Representation regarding Visual Impact Assessment in the EIA

Interested Parties Ref: **NWWFC-AFP012 and NWWFC-AFP011**

Proximities

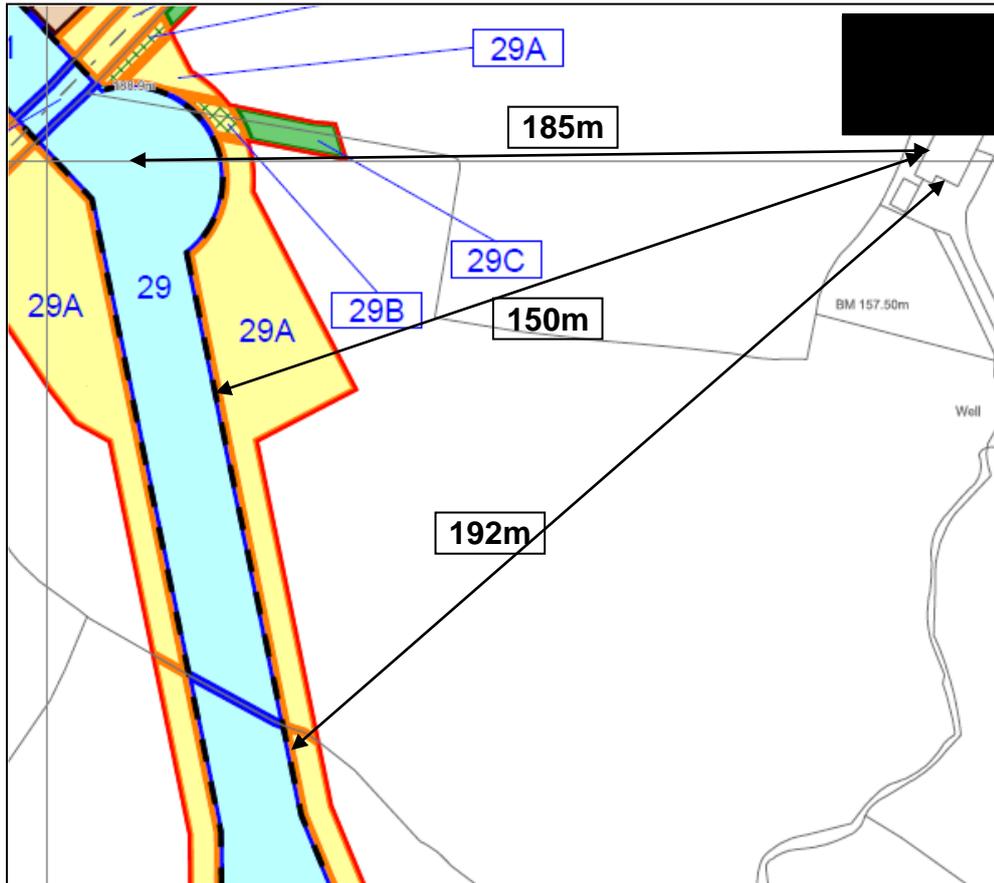
The Applicant states "Distance to nearest point on the edge of the Limits of Deviation is approx. 170m - this represents the worst case scenario in terms of potential nearest proximity to the Proposed Development."

This statement is incorrect. Actual distance to nearest point on the edge of the Limits of Deviation (worst case scenario) is approx. 150m. There are direct views from 4 windows at this distance.

We estimate 3 pylons and lines would be clearly directly visible to the west within 170m distance from centreline of limits of deviation. The applicant's claim of "greater than 200m" is not true at any point on this part of the route.
